**TO:** Mayor Mike Mason, City of Peachtree Corners  
**ATTN TO:** Diana Wheeler, Community Development Director, City of Peachtree Corners  
**FROM:** Mike Alexander, Director, ARC Center for Livable Communities  
**RE:** Development of Regional Impact (DRI) Review

**Name of Proposal:** Intuitive Surgical DRI 3720

**INTUITIVE SURGICAL DRI**  
**City of Peachtree Corners**  
**Natural Resources Group Review Comments**

## Development of Regional Impact Assessment of Consistency with the Regional Transportation Plan

Intuitive Surgical is a development of regional impact located in the City of Peachtree Corners. Figure 1 shows the site plan. The buildout year is 2027.

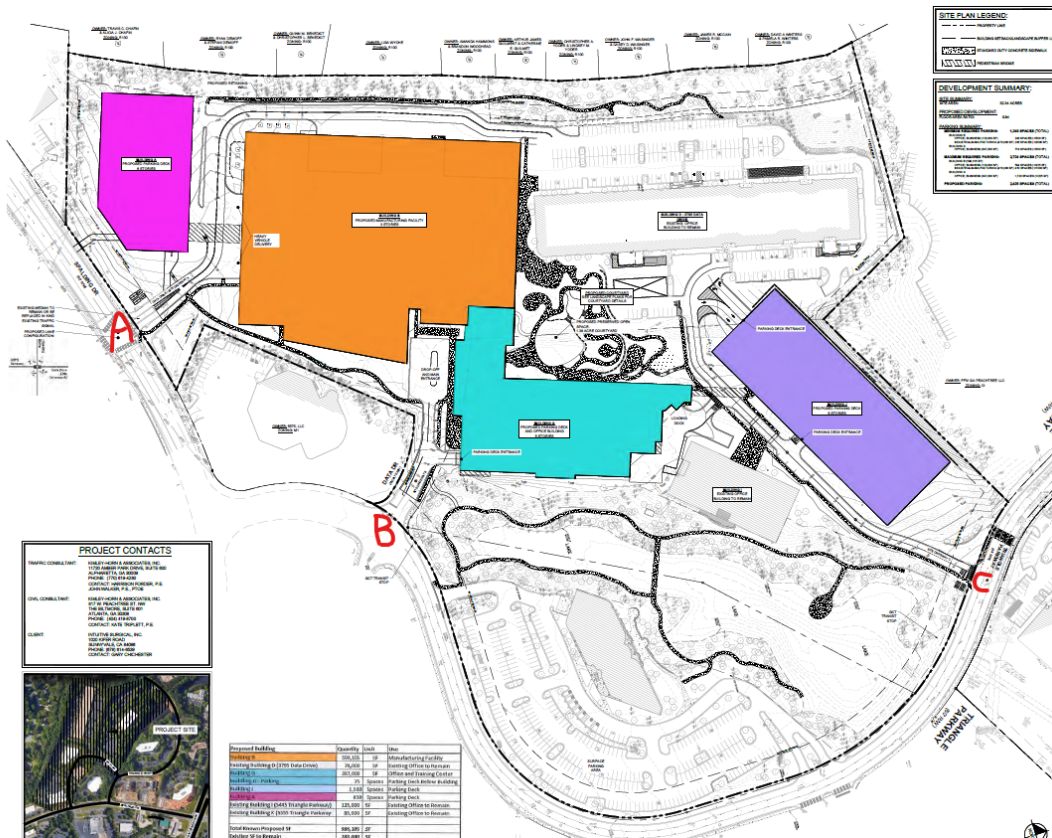
**Comment: Peachtree Corners Circle is a GCDOT road. In the TA, it is classified as Major Collector; however, per the GCDOT's long-range functional classification, it is a Major Arterial.**

- The trip generation shows a reduction of 264 daily trips, 40 AM peak, and 44 PM peak trips. We are concerned that the reduction is not supported by adequate multimodal facilities.
  - Will the sidewalks accommodate bicyclists?
  - Will the sidewalks connect to Gwinnett County Trails network?
- There are a couple of transit stops in the study area (2382785-3795 Data Drive and 2394821 – Triangle Parkway & Triangle Drive OB). Will these bus stops be improved to support transit users? According to the alternative mode reduction, there could be at least 40 people standing at a bus stop.
- Coordinate with GCDOT Transit Office on the location of bus stop 2382785-3795 Data Drive because it appears to be moved for construction.

### Spalding Drive at Data Drive (Driveway A) (Intersection 6)

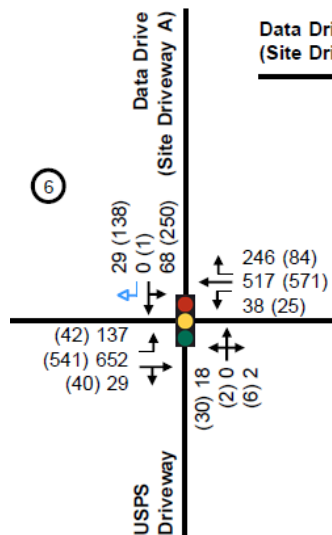
The applicant proposes to construct an exclusive southbound right-turn lane along Data Drive (Site Driveway A) (Figure 9 shown below).

- Show that the southbound and eastbound left-turn phases meet [GDOT's Policy 6785-2](#) Left-Turn Phasing requirements.
- Provide capacity analysis of the intersection with the following scenarios:
  - Southbound Left-turn phase – would require a left only/shared thru right lane.
  - Split phase for driveway/post office driveway – allows for shared left/thru lane shown above.
  - Remove median for left-turn only, shared left/thru, right turn only on site driveway. Split phase would be required.
  - Adding just a right-turn lane.
